City of Franklin

Meeting Agenda

Historic Zoning Commission

Monday, February 9, 2026

RIGHT SIDE ELEVATION- KITCHEN WINDOW PROPOSAL "A"

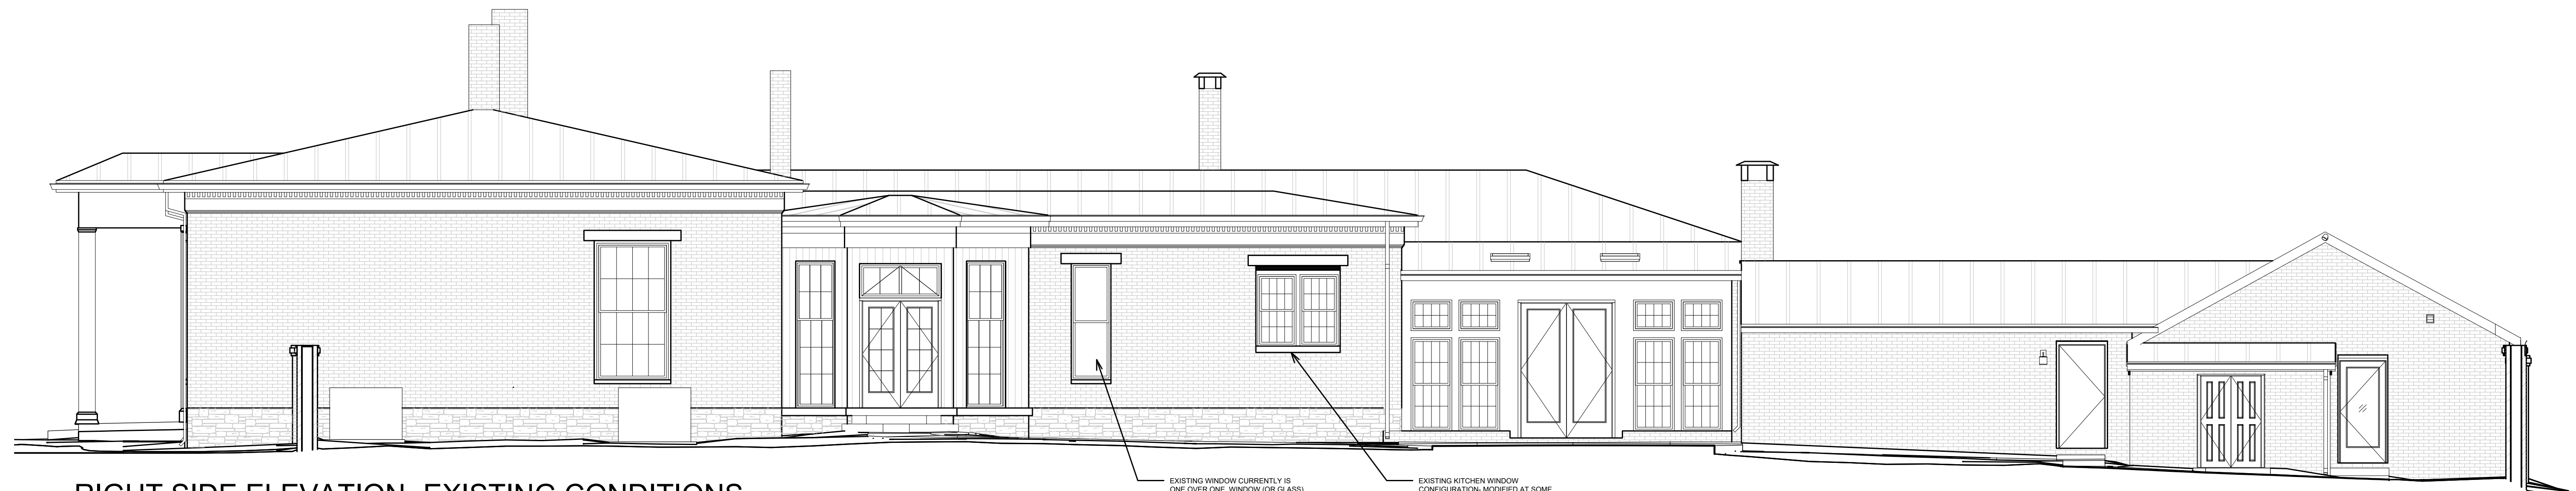
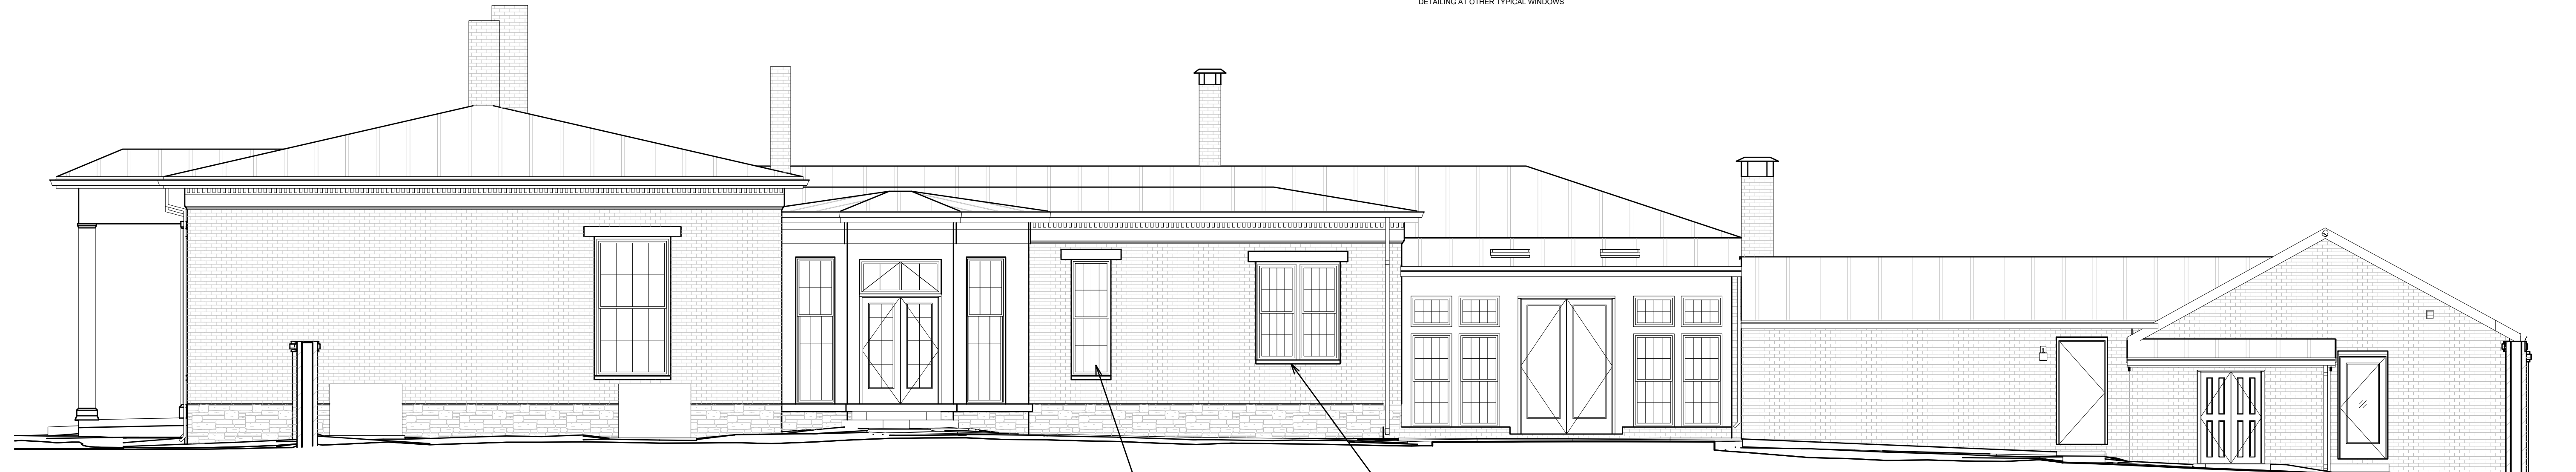
The replacement of the one-over-one window does not appear to have enough information for staff to provide a recommendation. However, the replacement of the existing pair of double-hung eight-over-eight windows with a larger pair of eight-over-eight windows does align with the Guidelines. The proposed windows are noted to be milled to match the profile of the windows on the left elevation of the house. The windows will be constructed out of Redwood or Mahogany, which is an appropriate window material per the Guidelines.

1. The proposal A with the double windows is approved.
2. The application must meet all the requirements of the City of Franklin prior to issuance of a building permit.
3. Any additional changes to the approved plans must be returned to the Preservation Planner or the Historic Zoning Commission for review and approval.

ELEVATIONS | WEST

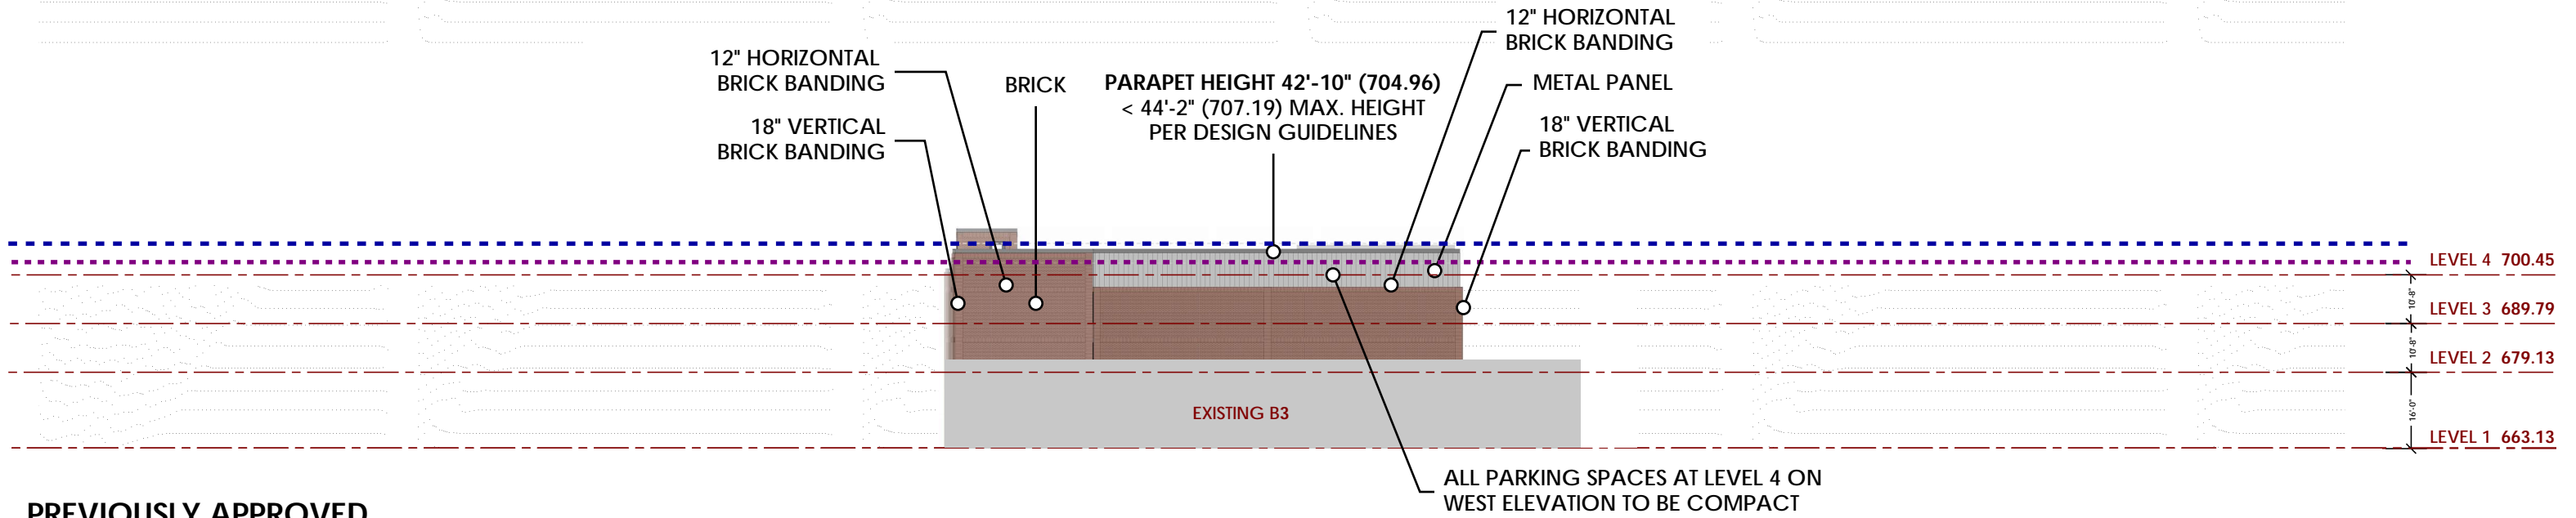
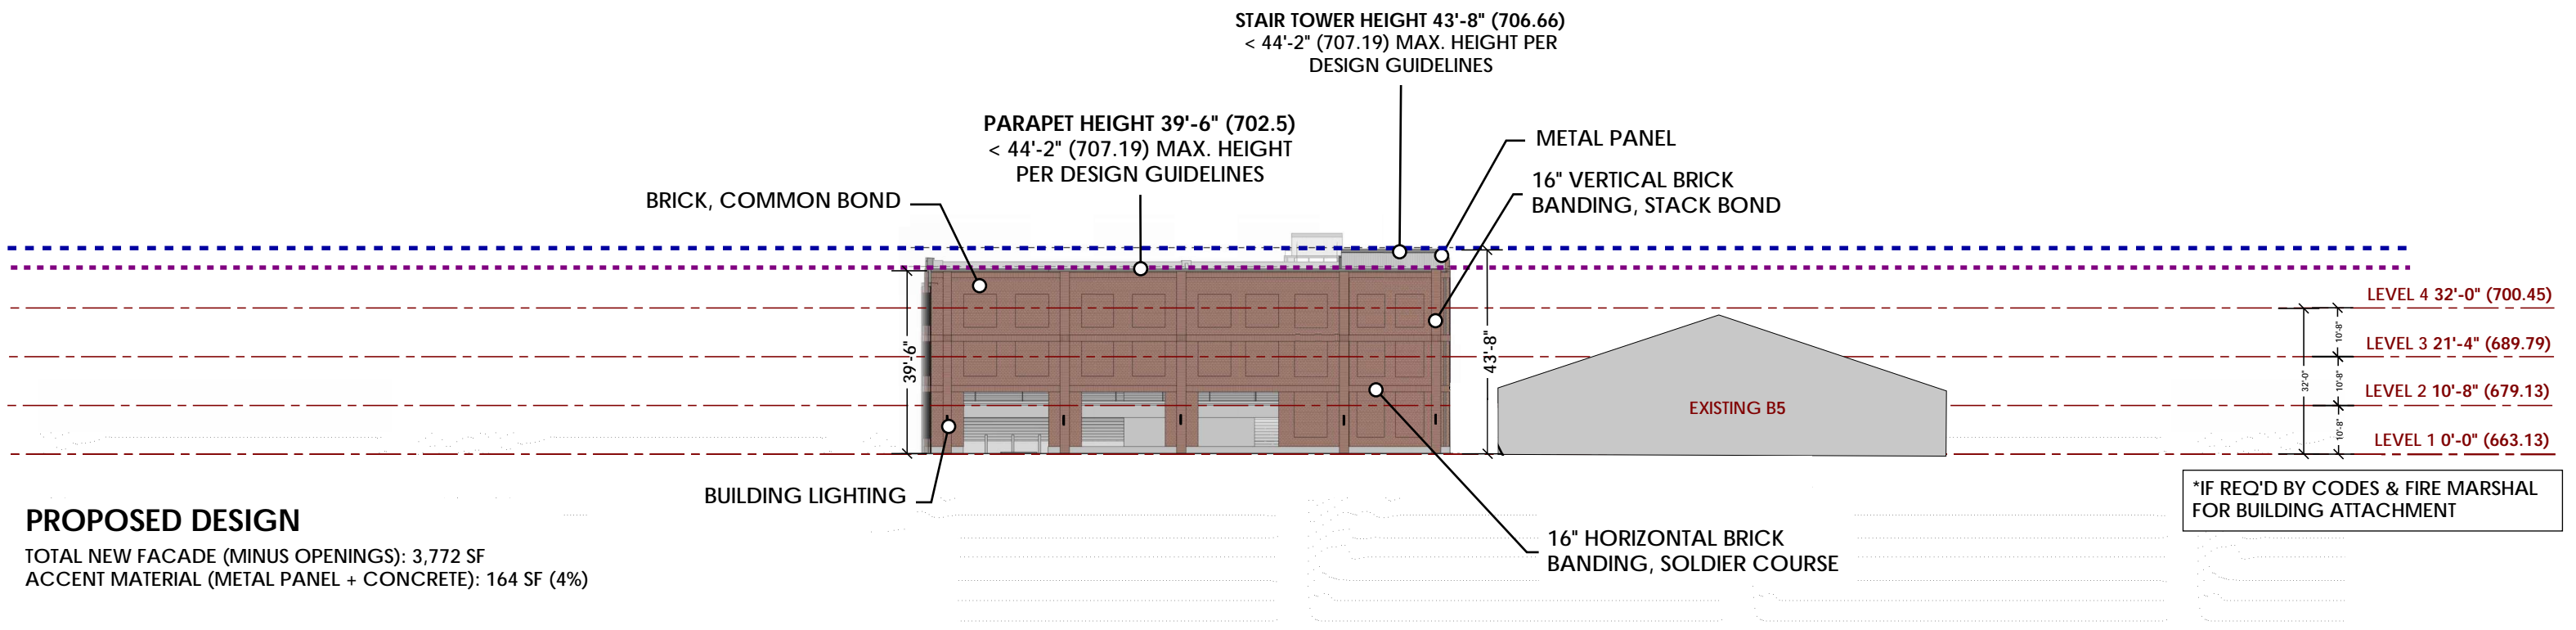
The Guidelines recommend aligning the architectural features of the new building with the existing buildings. The design has incorporated the feedback from the December HZC meeting to alter the West elevation to have the window openings read as bricked in windows to eliminate the openings on the facade in hopes of relieving concerns of seeing headlights from Franklin Road from the floors of the garage. Additionally, the applicant has included a window study of adjacent windows at the Factory to show that the proposed windows are compatible in size with what exists on the site.

1. All parking spaces on the top floor of the West elevation (facing Franklin Road) shall be compact spaces to ensure limited visibility from Franklin Road.
2. The building shall utilize traditional brick construction to align with the Guidelines.
3. A metal sample of the color of the building shall be provided to the Preservation Planner prior to issuance of a building permit.
4. The proposed lighting shall utilize warm, white illumination. Any additional illumination other than what is noted in the application shall be subject to HZC review and approval.
5. The application must meet all the requirements of the City of Franklin prior to issuance of a building permit.
6. Any additional changes to the approved plans must be returned to the Preservation Planner or the Historic Zoning Commission for review and approval.

A0.0

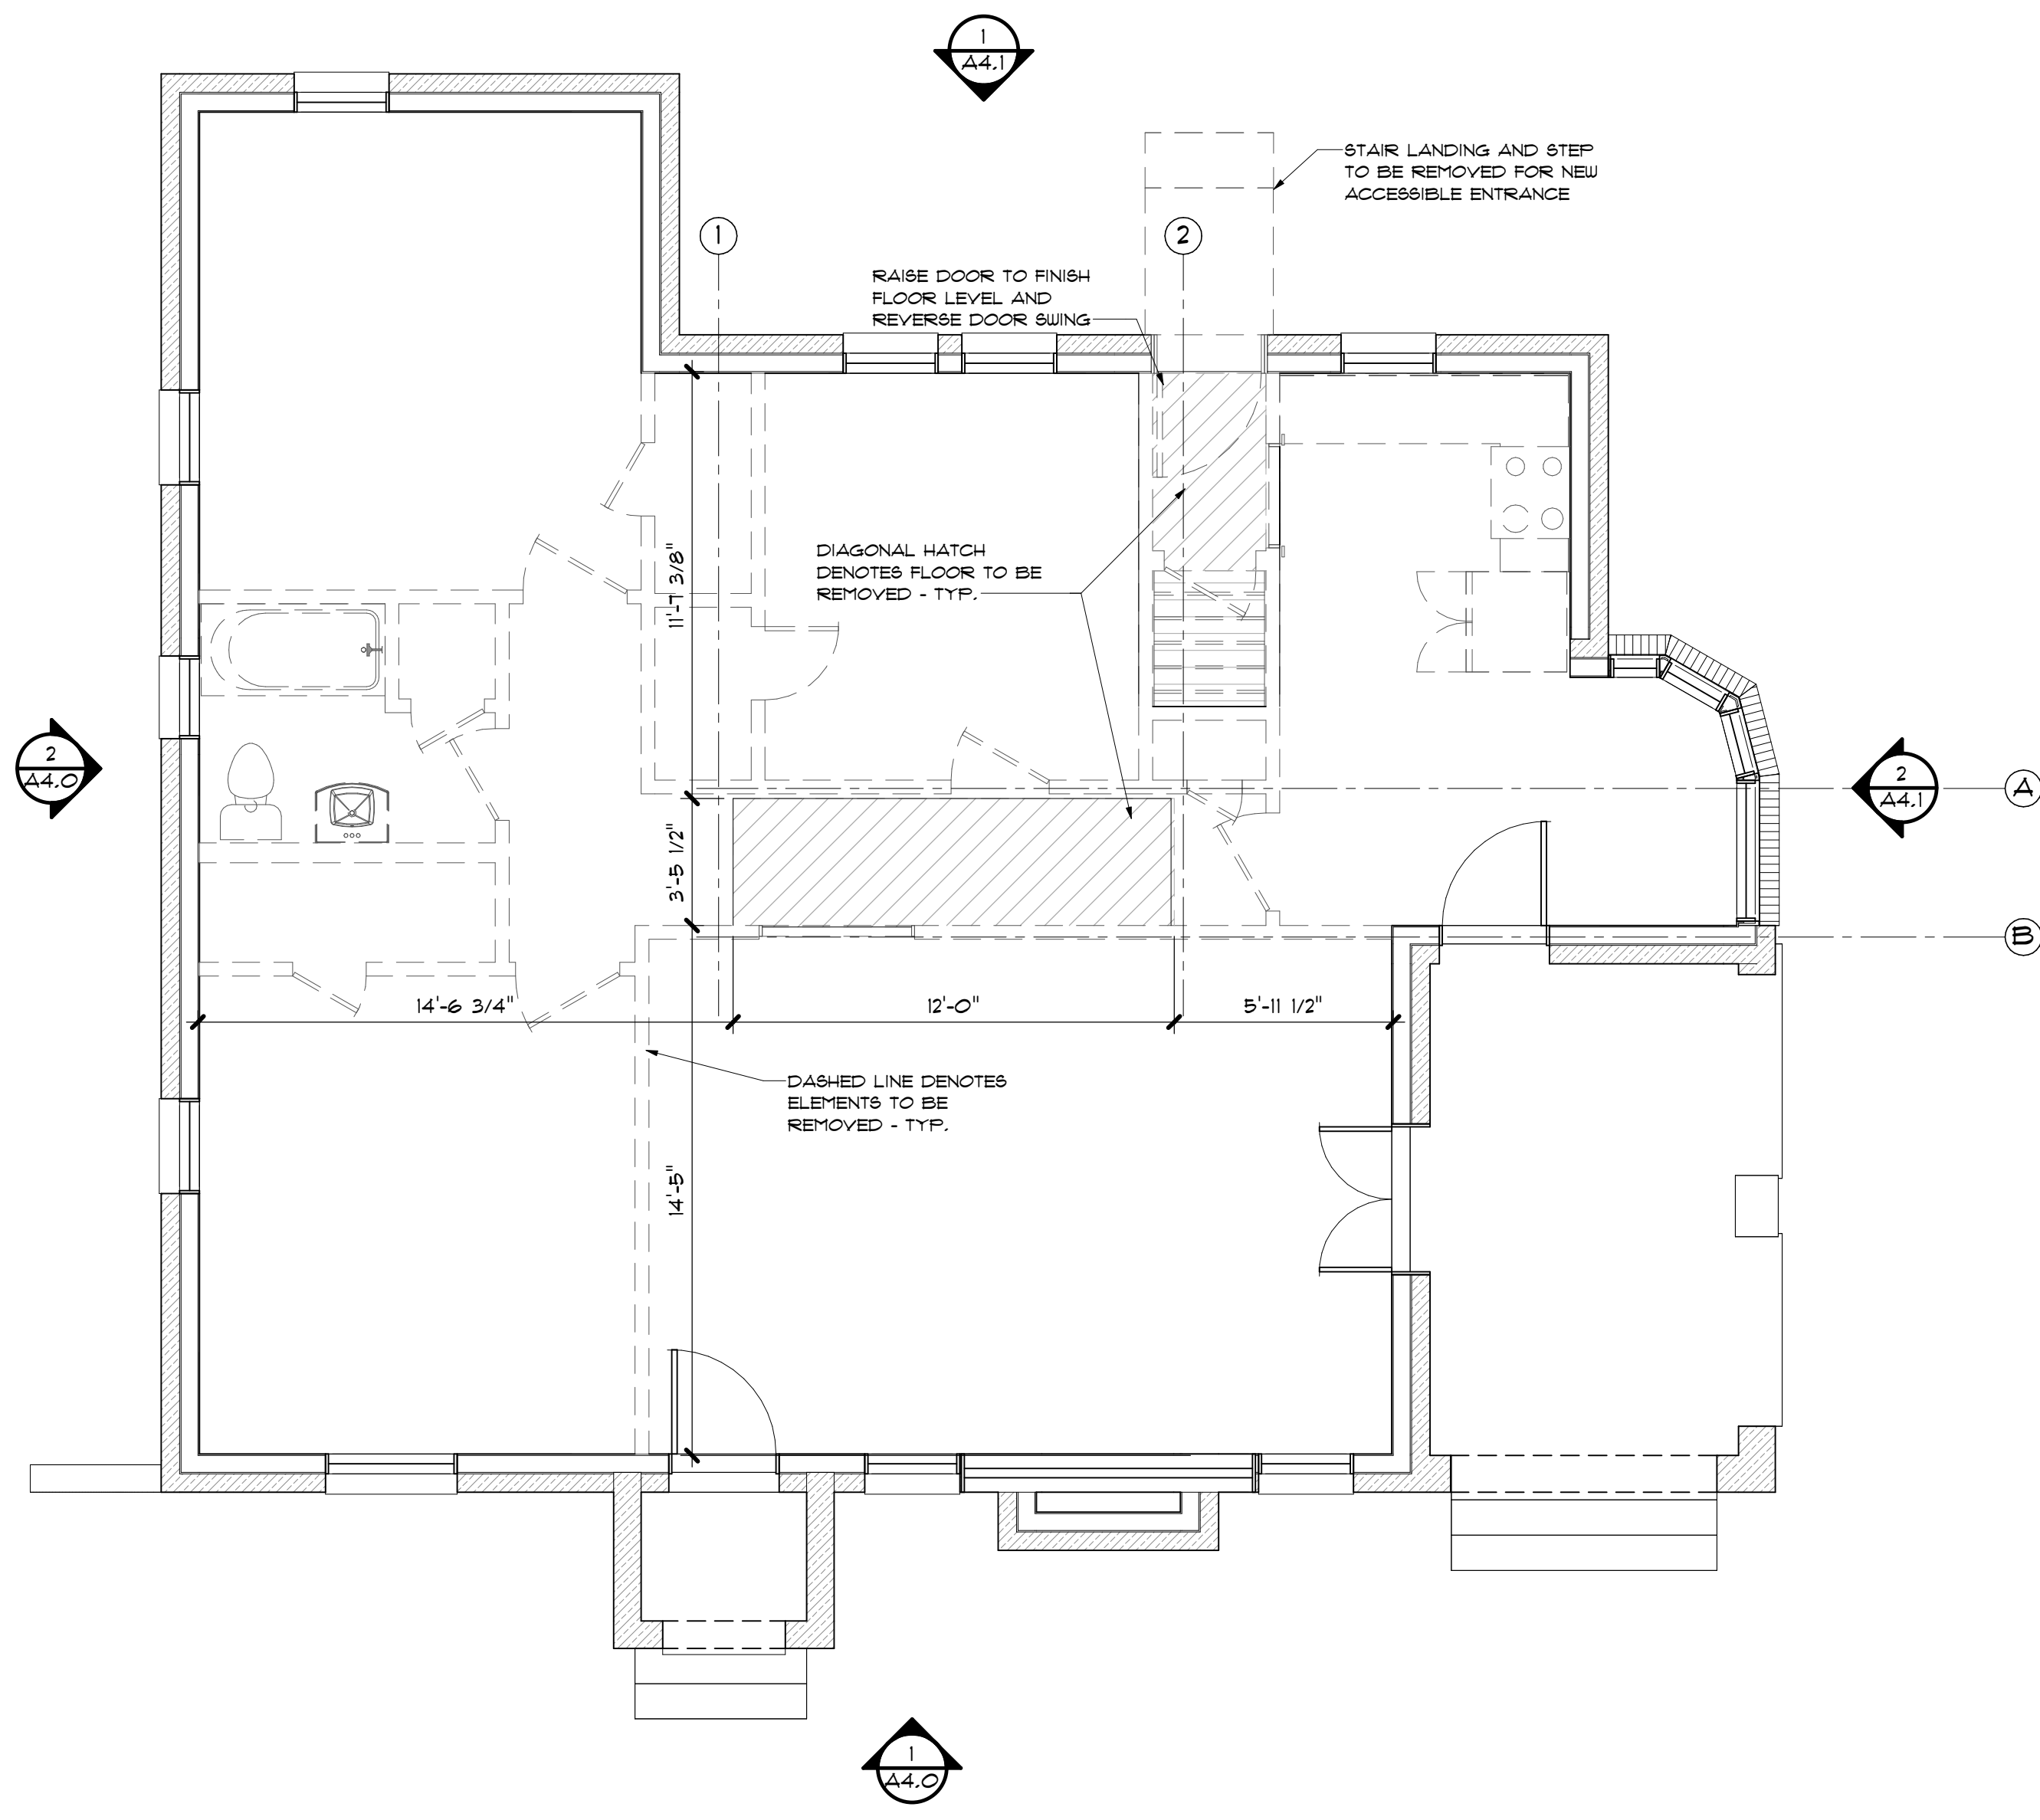
- Provide additional details on the total square footage of the building. Based on the existing square footage of the home (taken from the County), plus the new square footage being

added upstairs, staff calculates a total square footage of 2,835. Parking is calculated at 2.85 spaces per 1,000sf. $2.85 \times 2.8 = 7.98$. Therefore, staff finds that 8 spaces are needed, not 5.
